**SUBDIVISION &  
ZONING AMENDMENT STAFF REPORT****Date: January 7, 2021****APPLICANT NAME** Majure Real Estate Company, LLC (Edward Majure, Agent)**SUBDIVISION NAME** Lakeside Commercial Park Subdivision, Twelfth Addition,  
Resubdivision of Lots 4 and 5**LOCATION** 3755 Cottage Hill Road and 704 Lakeside Drive West  
(South side of Cottage Hill Road, 200'± West of Lakeside  
Drive West, extending to the West side of Lakeside Drive  
West, 150'± South of Cottage Hill Road)**CITY COUNCIL  
DISTRICT** Council District 4**PRESENT ZONING** B-1, Buffer Business District and B-2, Neighborhood  
Business District**PROPOSED ZONING** B-3, Community Business District**AREA OF PROPERTY** 3 Lots/ 1.3± Acres**CONTEMPLATED USE** Subdivision Approval to create three (3) legal lots of record  
from three (3) existing legal lots; and Rezoning from B-1,  
Buffer Business District, and B-2, Neighborhood Business  
District, to B-3, Community Business District.

# SITE PLAN

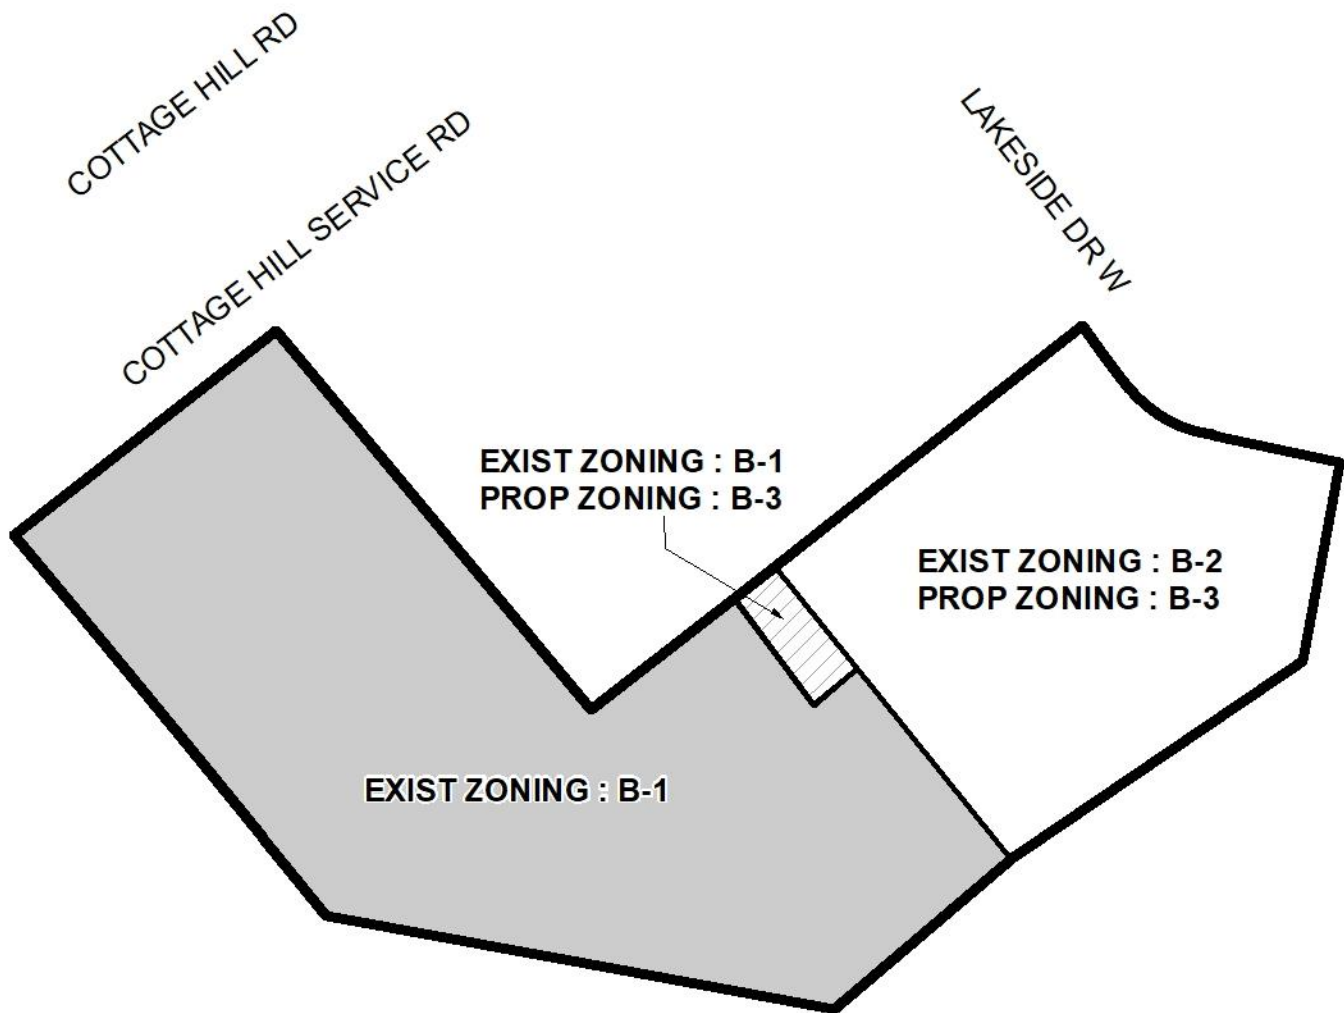
Verify the location of the reciprocal easement on Lot 2 to include the existing driving aisle on Lot 1 as necessary. Lots 1 and 2 are limited to one shared curb cut to Cottage Hill Road Service Road and Lot 3 is limited to one curb cut to Lakeside Drive West. Driveway size, location, and design to be approved by Traffic Engineering and conform to AASHTO standards. Required on-site parking, including ADA handicap spaces, shall meet the minimum standards as defined in Section 64-6 of the City's Zoning Ordinance.

The applicant proposes to create three (3) legal lots of record from three (3) existing legal lots. The lot size is depicted in square feet and acres on the plat and exceeds the minimum lot size requirements of Section V.D.2. of the Subdivision Regulations. If approved, the lot sizes should be retained in square feet and acres on the Final Plat or a table should be furnished on the Final Plat providing the same information.

As illustrated, Lots 1 and 2 front Cottage Hill Service Road a marginal access street depicted as having a right-of-way width of 30 feet. An access road would typically have a 40-foot right of

way width (30 feet of pavement and 10 feet of divider); however, based on the existing right-of-way for Cottage Hill and its development to the Major Street Plan standards, it appears that additional right-of-way may not be needed. Therefore, no further dedication will be required at this time. Lot 3 fronts Lakeside Drive West a minor street with curb and gutter, depicted as having a compliant right-of-way width of 50'. As such, no right-of-way dedication is required at this time. If approved, the right-of-way widths should be retained on the Final Plat.

The preliminary plat illustrates compliant minimum building setback lines for all proposed Lots and should be retained on the Final Plat.

The plat indicates a reciprocal easement for ingress and egress located on Lot 2 and should be retained on the Final Plat and include a note stating that no structures shall be constructed within any easement without the permission of the easement holder.

Section V.D.1. of the Subdivision Regulations states that panhandle and flag lots should generally not be allowed, but may be permitted in locations where varied and irregularly-shaped lot designs are common and the informality of design is consistent with other lots in the vicinity. As irregularly-shaped lots do exist in the area a waiver of Section V.D.1. may be in order.

It's important to note that as illustrated the proposed subdivision creates shared access and parking between Lots 1 and 2 for which a Planned Unit Development (PUD) would be required. Typically, this would require approval by the Planning Commission as other approvals are also necessary (those included in this group application). However, as no new development is currently being proposed for Lot 2, the Commission may approve the application as proposed; subject to the submission and approval of an Administrative PUD prior to any additional development on Lot 2.

- 1) Retention of the lot sizes in both square feet and acres on the Final Plat or provision of a table providing the same information;
- 2) Retention of the rights-of-way widths for Cottage Hill Service Road and Lakeside Drive West on the Final Plat;

- 3) Retention of compliant minimum building setback lines along all frontages on the Final Plat;
- 4) Placement of a note on the Final Plat stating that no structure may be constructed or placed within any easement without the permission of the easement holder;

- 5) Submission and approval of an Administrative PUD prior to any additional development on Lot 2;
- 6) Full compliance with Engineering comments: *(FINAL PLAT COMMENTS (should be addressed prior to submitting the FINAL PLAT for review and/or signature by the City Engineer): A. Provide all of the required information on the SUBDIVISION PLAT (i.e. signature blocks, signatures, certification statements, written legal description, required notes, legend, scale, bearings and distances) that is required by the current Alabama State Board of Licensure for Professional Engineers and Land Surveyors. B. Provide reference, on the map and the description, to a monumented corner. C. Provide and label the monument set or found at each subdivision corner. Clarify NOTE #4. D. Provide and label the monument set or found at each subdivision corner. E. Provide the Field Date in NOTE #3. F. Provide the Surveyor's and Owner's (notarized) signatures. G. Add a note to the SUBDIVISION PLAT stating that as shown on the 1984 aerial photo (FLIGHT 24 - #80) LOTS 1, 2, and 3 will receive historical credit of existing (1984) impervious area towards stormwater detention requirement per Mobile City Code, Chapter 17, Storm Water Management and Flood Control) as follows: LOT 1 – 9,200 sf, LOT 2 – 3,900 sf, and LOT 3 - NONE. H. Add a note that a Land Disturbance permit will be required for any land*
